Notice of Determination

Project Title: Redlands Passenger Rail Project (RPRP)

Following additional coordination with local stakeholders, including the San Bernardino County Flood Control District (Flood Control District) and completion of the Project's 90 percent design, SBCTA is proposing several design refinements to the approved Project. In general, these design refinements are in response to additional hydraulic modeling of the Mission Zanja Channel (MZC) and Santa Ana River (SAR) as part of the approved Project's final design.

Figure 2: Foundation Design at Bridge 3.4 (Vertical)

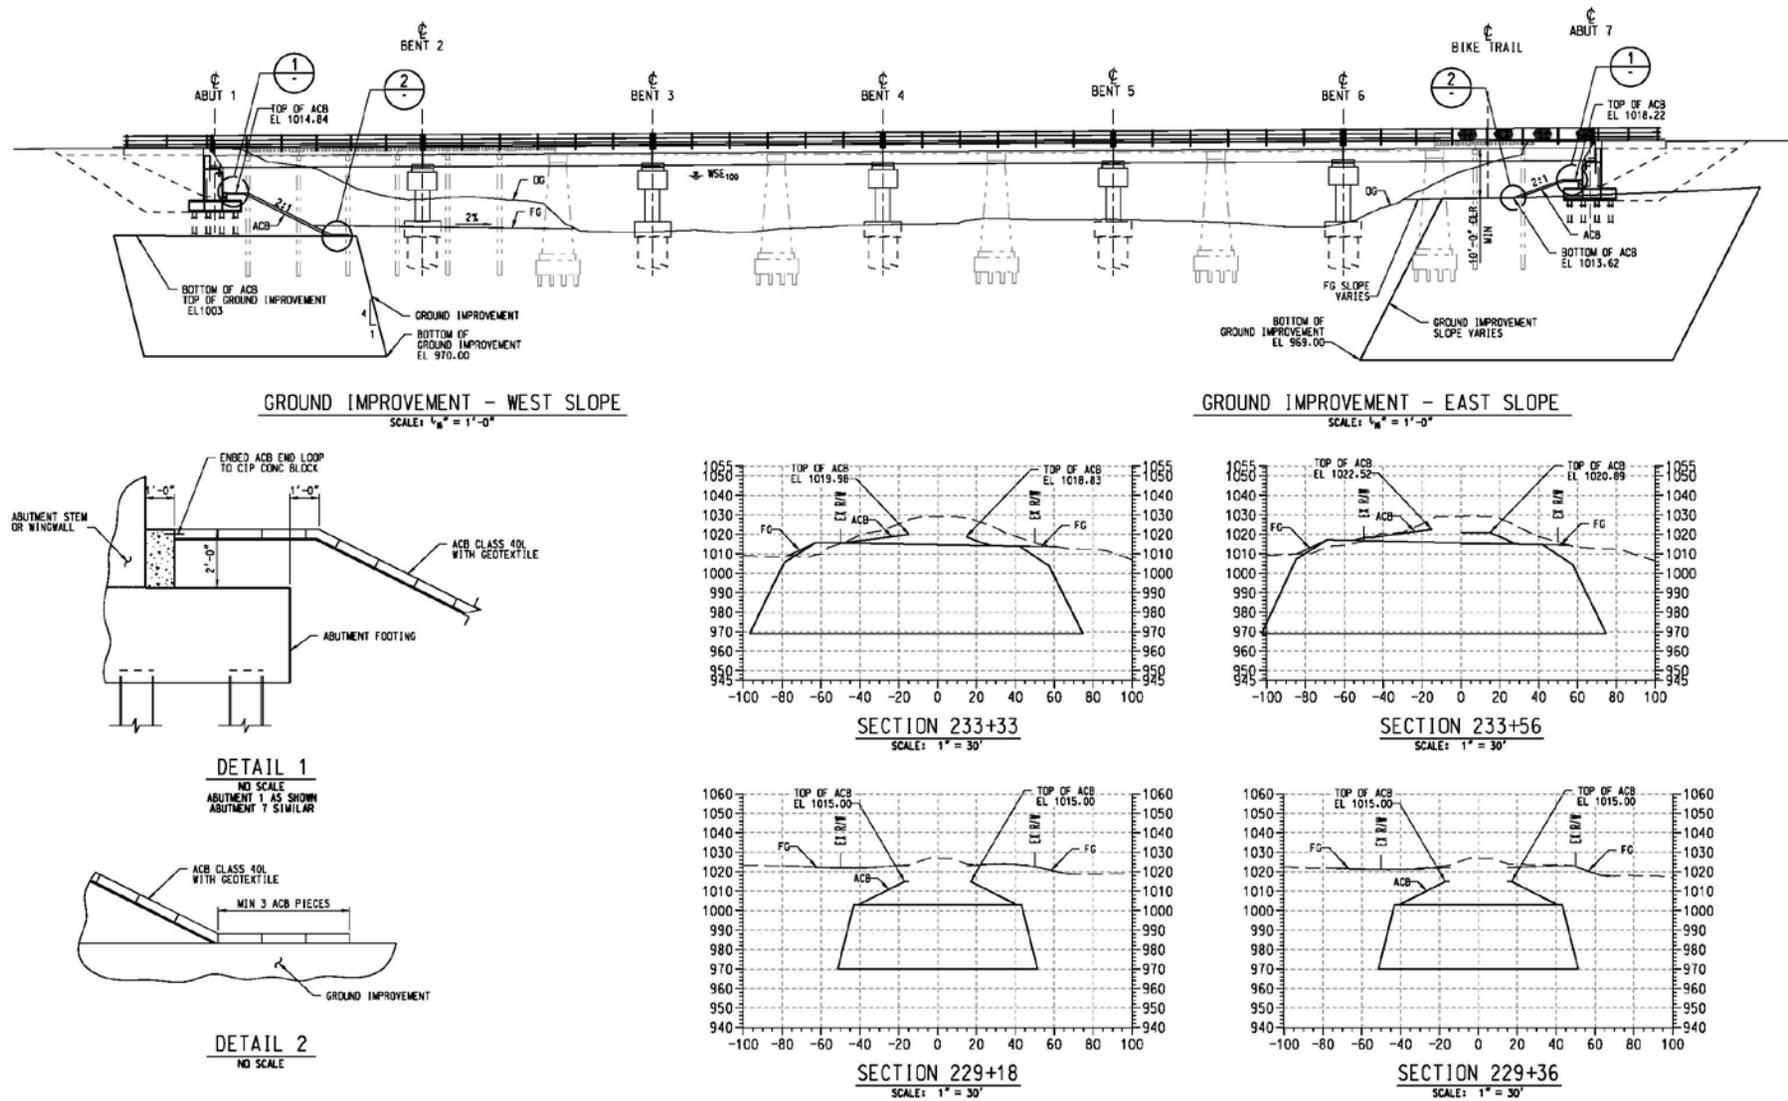
- A. Revised Abutment and Pier Scour Protection: Following additional hydrologic/hydraulic (H&H) modeling and geotechnical investigation as part of the approved Project's final design, SBCTA has identified scour conditions and liquefiable soils at Bridge 3.4 that require the incorporation of revised ground improvement measures for the bridge piers and abutments. The 90 percent design reflects the incorporation of a soil slurry/cement within deeper excavations; capped with articulate concrete block (ACB) (see Figure 2 of Attachment A). These ground improvements would be required at both the west and east bridge abutments and would result in a widening of the channel to 380 feet (previously 365 feet).

Figure 3: Construction Limits at Bridge 3.4 (2015 and 2017 Comparison)

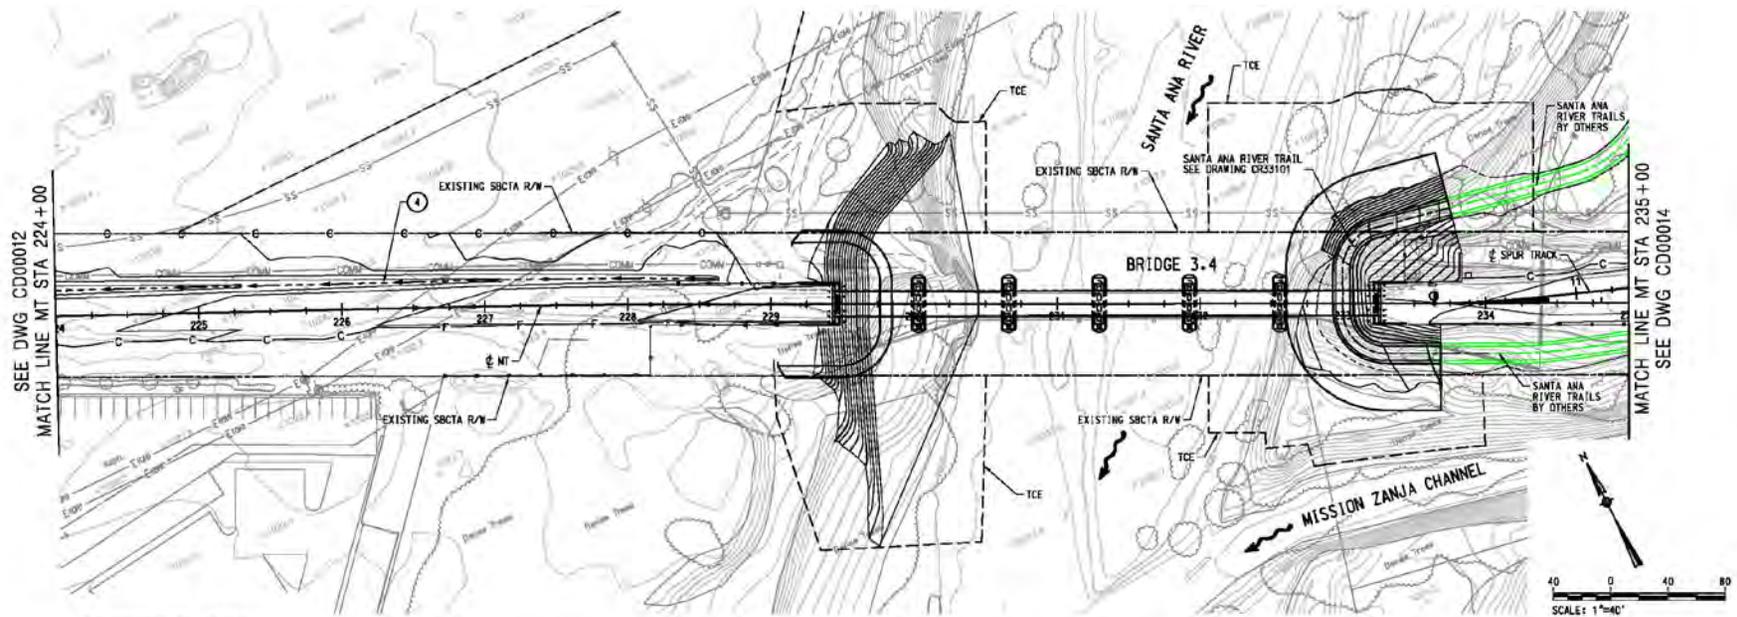
- B. Bank Protection Improvements: Based on additional H&H modeling, additional channel improvements along the western bank are required to address the potential for meandering of the channel to the north of Bridge 3.4. SBCTA is proposing the use of a combination of ACB and vegetated riprap and/or revetment to stabilize the western bank; north and south of the bridge (see Figure 3 of Attachment). The proposed protection would support plant growth and propagation, including the placement of willows (*Salix* spp.) and other native understory plantings. These improvements would extend beyond the previously evaluated physical footprint at Bridge 3.4 (see Figure 3 of Attachment A).

Figure 4: SAR Bike Trail (Proposed Alignment)

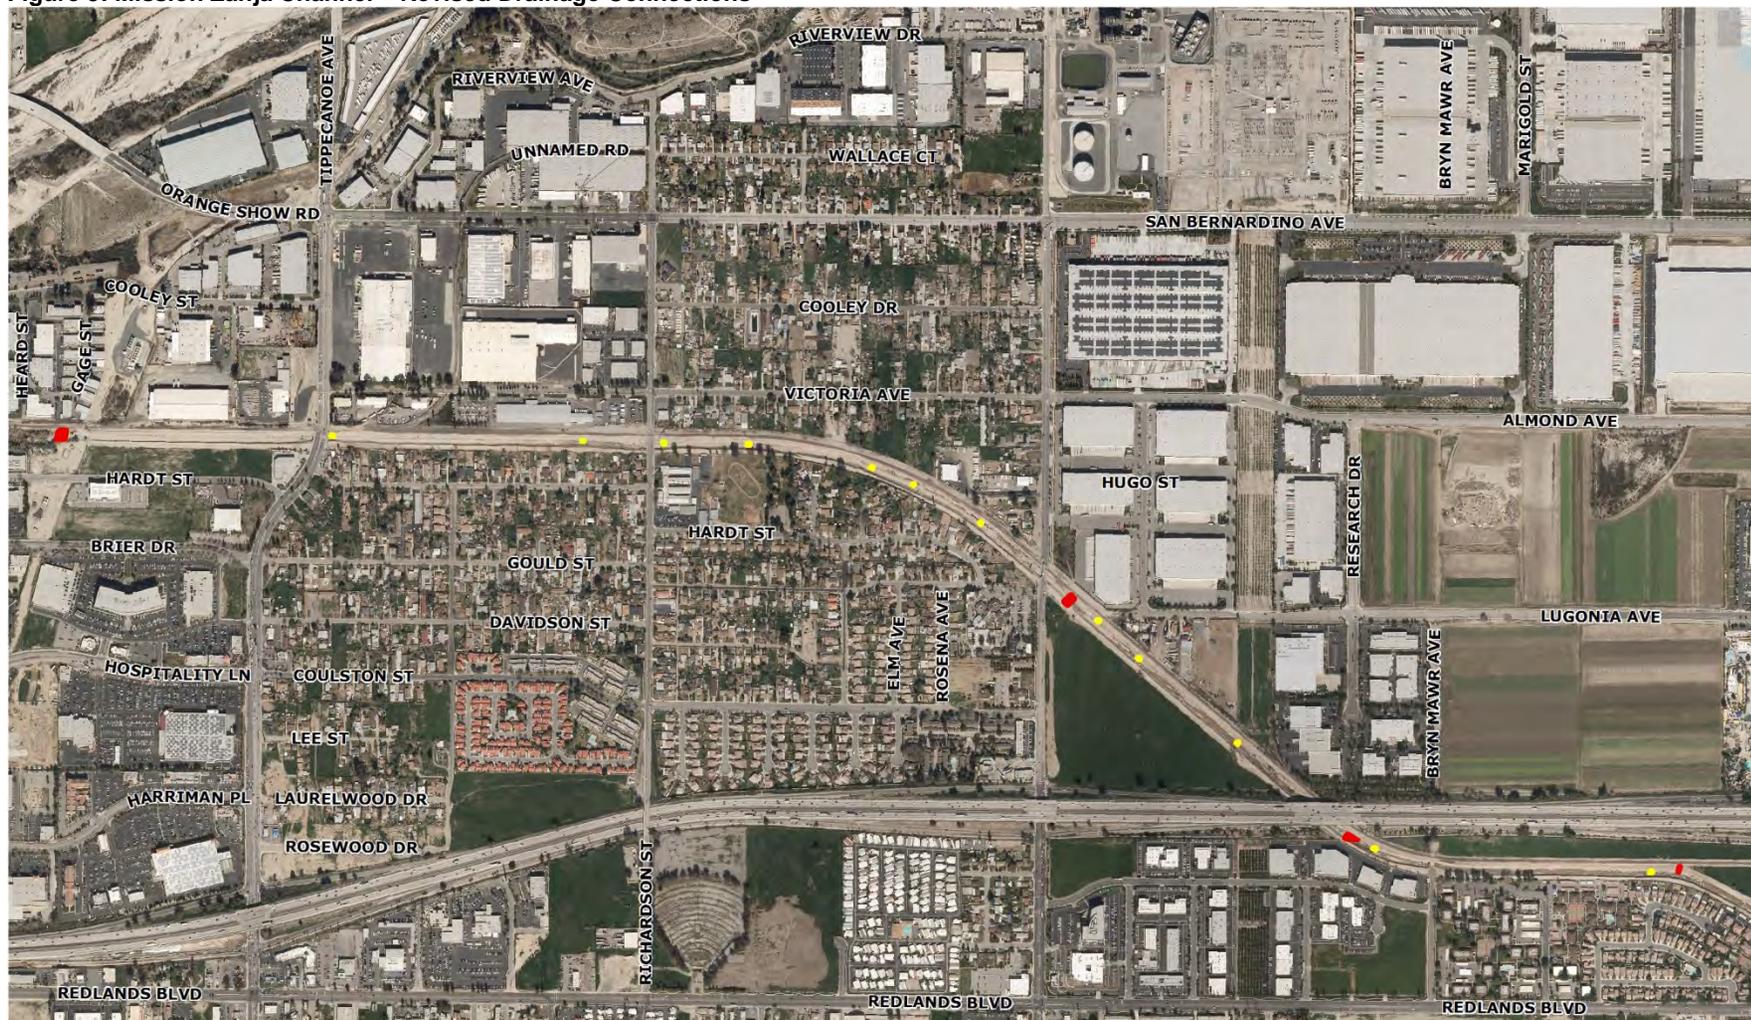
- C. Incorporation of SAR Bike Trail: As required by Mitigation Measure (MM) PCS-1, SBCTA has coordinated with the County Department of Public Works regarding the placement of the SAR Trail across SBCTA's right-of-way (ROW). As proposed in the 90 percent design, the SAR trail would run along the eastern bank and underneath Bridge 3.4 near the seventh abutment (see Figure 4). ACB would be used on the bank above the trail and the trail surface with a protection wall composed of concrete placed below the trail. The County's Department of Public Works will be responsible for constructing the SAR Trail connections to the north and south of SBCTA's ROW.

Figure 5: Mission Zanja Channel – Revised Drainage Connections

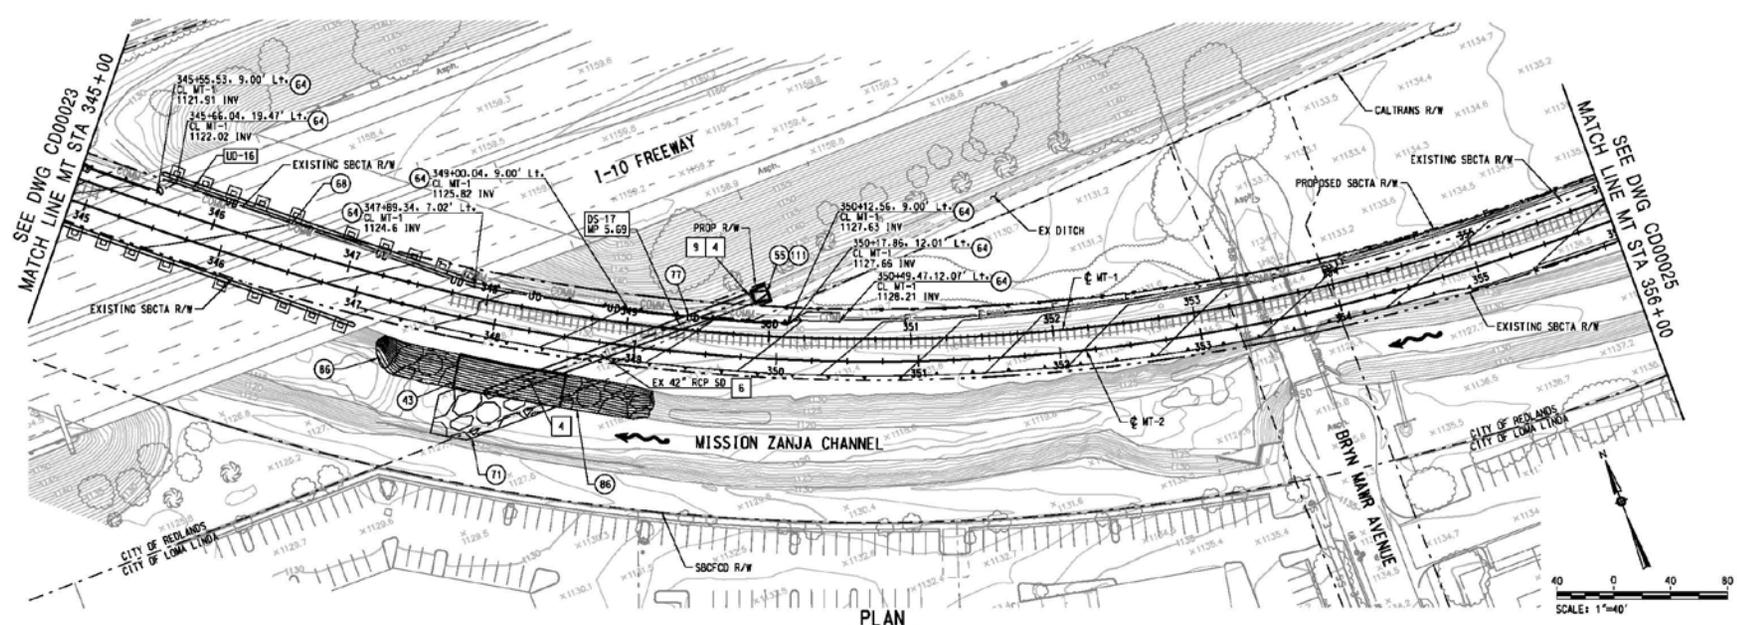
- A. *Removal of Previously Proposed Drainage Connections to the MZC:* The approved Project and Final EIR considered the protection in place, replacement, and construction of new drainage connections to the MZC. The approved Project’s preliminary design reflected the placement of 12 new drainage connections to the MZC. An additional three existing drainage connections would be reconstructed to address the loading requirements of the track infrastructure and locomotive train sets (e.g. Metrolink). Nine of these drainage connections would not be constructed as part of the refined Project. Figure 5 in Attachment A illustrates the locations of these drainage connections and provides an indication of those removed and retained as part of the refined Project.

Figure 8: Replacement of Existing Drainage Connection East of Bryn Mawr Avenue

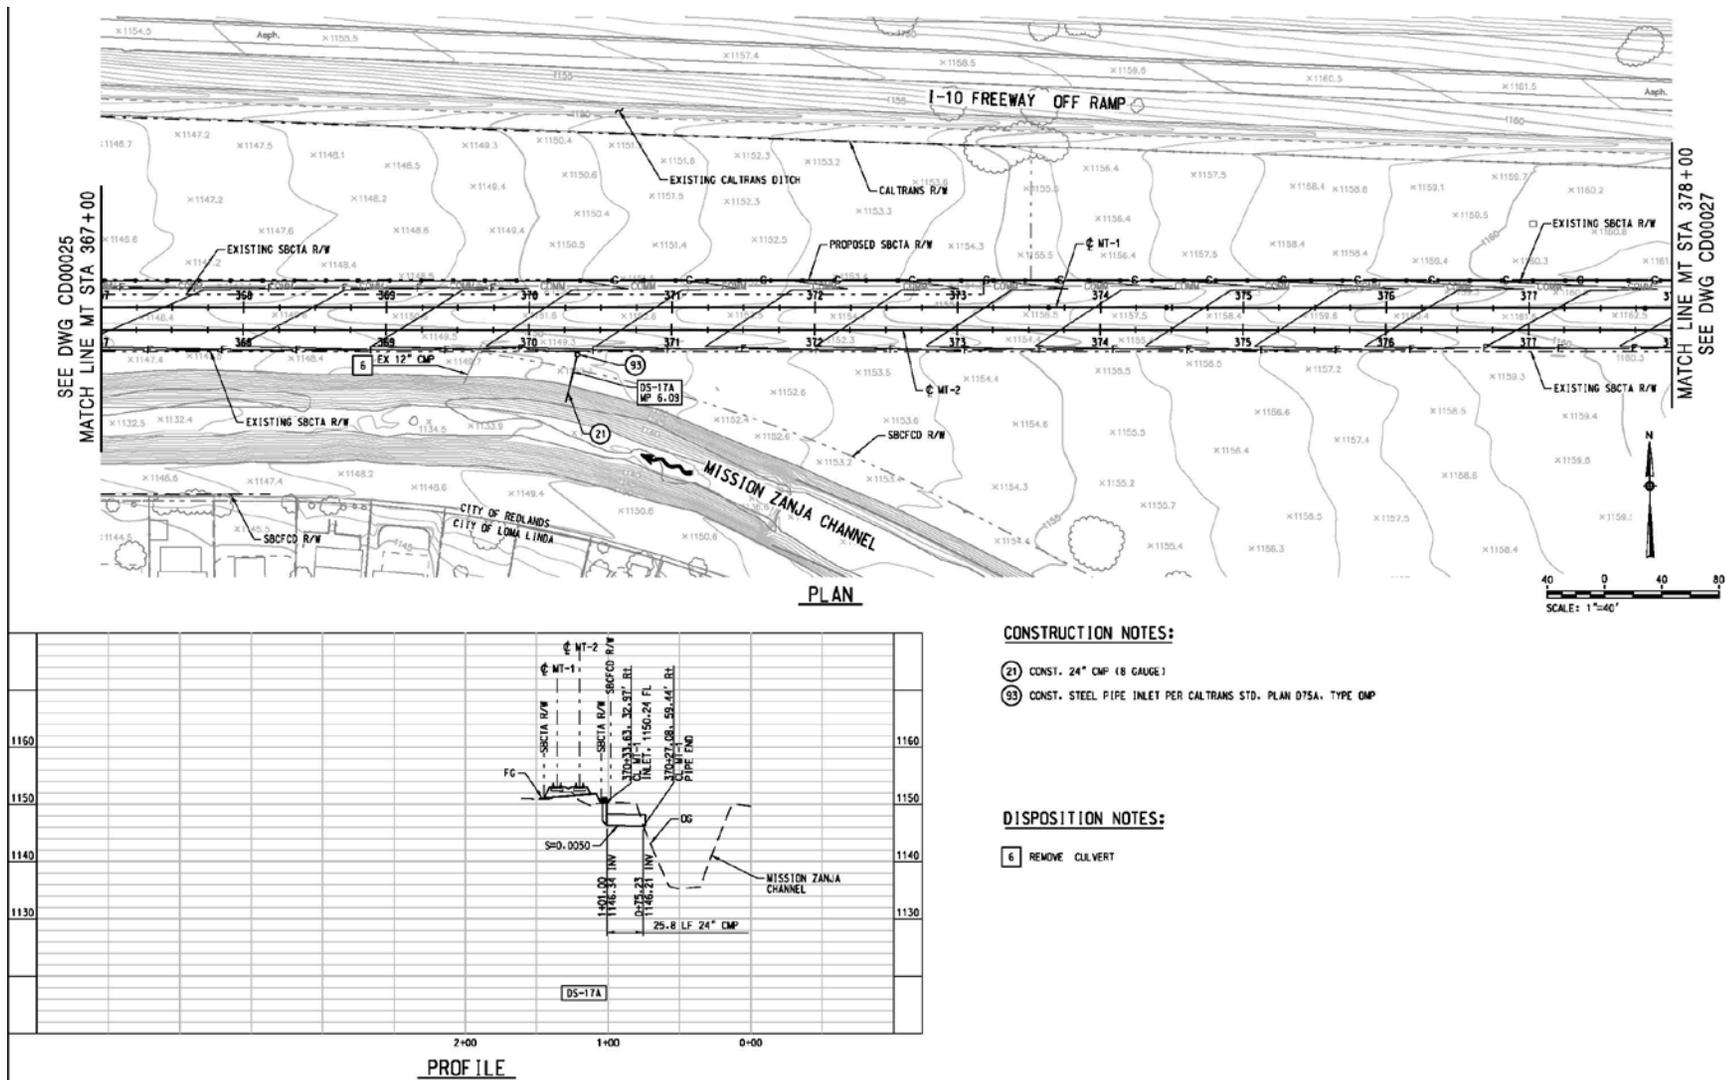
- B. *Replace Three Existing Drainage Connections:* The refined Project would include the replacement of three existing drainage connections along the MZC east of Mountain View Avenue. At Lugonia Avenue, an existing wooden box culvert (deteriorated) would be replaced with a 48-inch RCP with associated outlet protection (see Figure 6 in Attachment A). At I-10, an existing 42-inch RCP would be replaced with a 4-foot by 8-foot reinforced concrete box (RCB) culvert with associated outlet protection (see Figure 7 of Attachment A). East of Bryn Mawr Avenue, an existing 12-inch RCP would be replaced with a 24-inch CMP (see Figure 8 of Attachment A).

Figure 9: New Drainage Connections West of Gage Canal

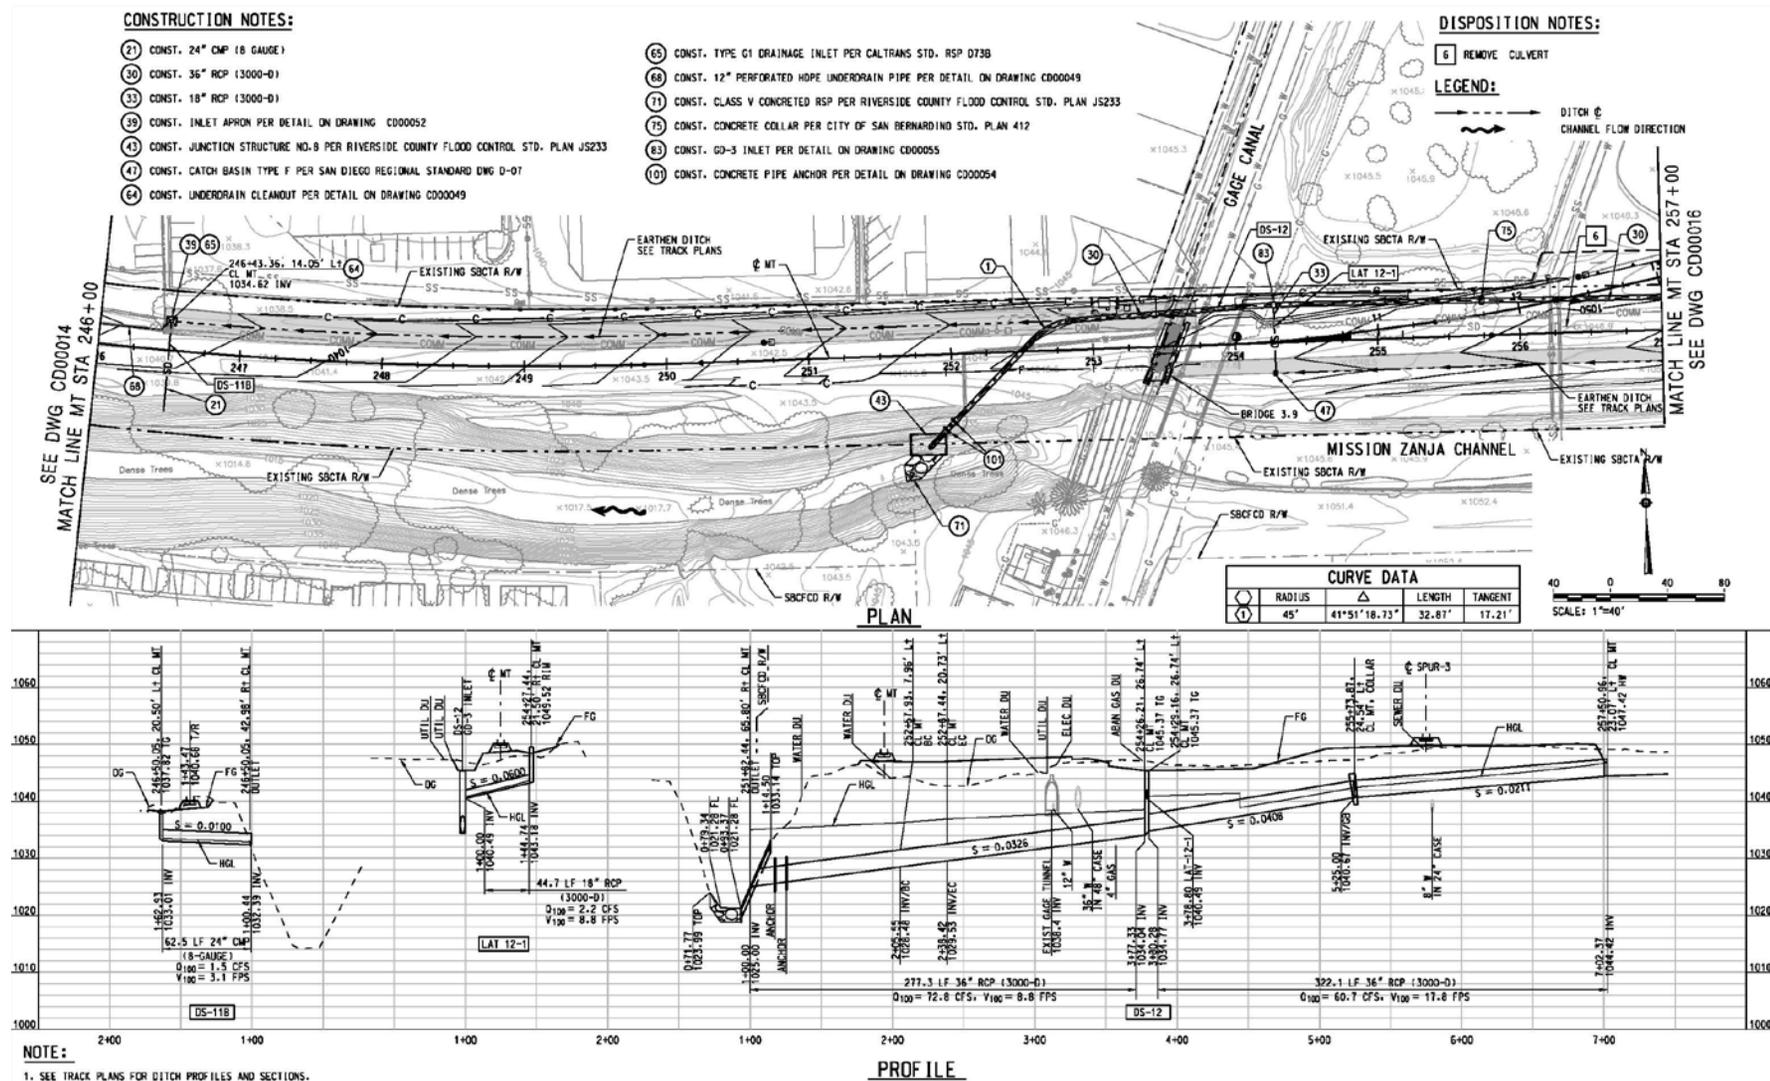
- C. *Construct Three New Drainage Connections West of the Gage Canal:* The approved Project contemplated one new drainage connection west of the Gage Canal (MP 3.8). As part of the refined Project, a total of three new connections would be constructed; one at the confluence with the SAR. The easternmost connection would be constructed just west of the Gage Canal and would consist of a 36-inch diameter reinforced concrete pipe (RCP) with associated outlet protection. Approximately 500 feet west, a second 24-inch corrugated metal pipe (CMP) would be installed. Figure 9 illustrates the current design for these two drainage connections. A third 24-inch CMP would be constructed at Bridge 3.4 (see Figure 10 in Attachment A). These improvements would be constructed within SBCTA’s ROW.
